CITY OF ISSAQUAH
DEVELOPMENT SERVICES
DEPARTMENT DEVELOPMENT
COMMISSION

STAFF REPORT

FILE NO.: Community Conference: COM15-00003

PROJECT: 355 Sunset Way (Issaquah Apartments)

Figure 1. East Elevation showing relation of building heights from the less intense single-family use across the alley (left) and the proposed multi-family building.

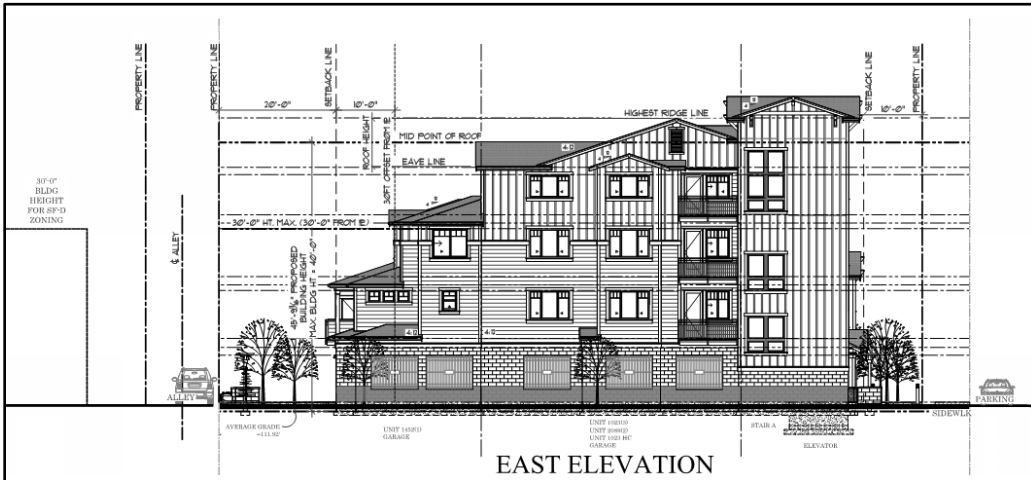
Staff Analysis: The roof is broken up into smaller pitched roofs at various heights. The East and West Elevations show the cascading roof form. The most critical side of the building is the rear, given the single-family zoning across the alley from the project site. This side of the building is well modulated, as shown in Figure 1, East Elevation. The elevation drawing also shows the variety of building materials, including windows and balconies, that are used to further articulate the building to address the human scale. Figure 2 shows the view of the building from the single-family properties across the alley. The tallest roofs are significantly set back and will not be visible from the alley because the building. While the height of the elevator and stair tower exceeds the maximum height allowed, this is exempt from the height limit per IMC18.07.060.B.4 (g) and (h). The elevator and stair tower should be further refined to mitigate the experience of its height from Sunset Way (see Figure 3), such as creating a stronger “top”.
